54-372 Connect 5 Instrument Cluster (ICC5) Nuisance Fault Code

TSB-54-372-FTL

Creation Date: 2025-02-04
Last Revision Date: 2025-04-01

Figure 1 shows what the fault code 'SA 23 ICC5 SPN 523021/ FMI 31' looks like on the ICC5 display.

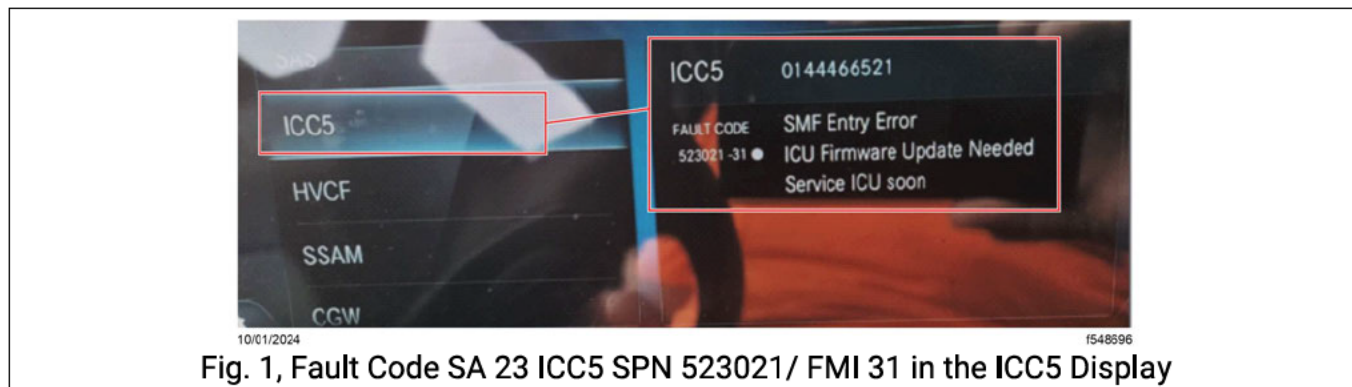
Vehicles equipped with a Connect 5 Instrument Cluster (ICC5) and ordered with the software package identified by sales codes 81Z-008, 81Z-308, or 81Z-808 (related to model year 2023 or software version 22.50.30) may display the fault code 'SA 23 ICC5 SPN 523021/ FMI 31 - The list of Electronic Control Units (ECUs) in the Warning Database (WDB) does not match the list of ECUs parameterized in PID 0x20.' This is considered a nuisance code and does not require any troubleshooting or programming changes.
